Serial No.: 10/695,018

**AMENDMENT**

**In The Drawings:**

**Discussion of Drawings Objection**

FIG. 1A (PRIOR ART)

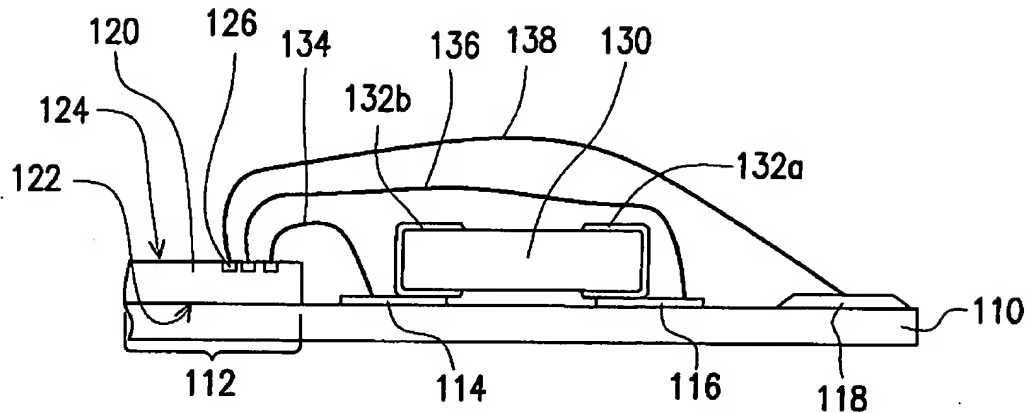
*Figures 1B and 2B are objected to as failing to comply with 37 CFR 1.83(a) because they show inconsistent dispositional relationships between the passive component and the electrodes 132b and 232b and it is not clear whether the electrodes are at the top end of the passive element or at the sides thereof.*

In response thereto, Applicants have amended Figures 1A, 1B, 2A, and 2B to clarify the dispositional relationships between the passive component and the electrodes 132b and 232b and to clarify that the electrodes are at the top end and bottom end of the passive element. Withdrawal of the objection is respectfully requested.
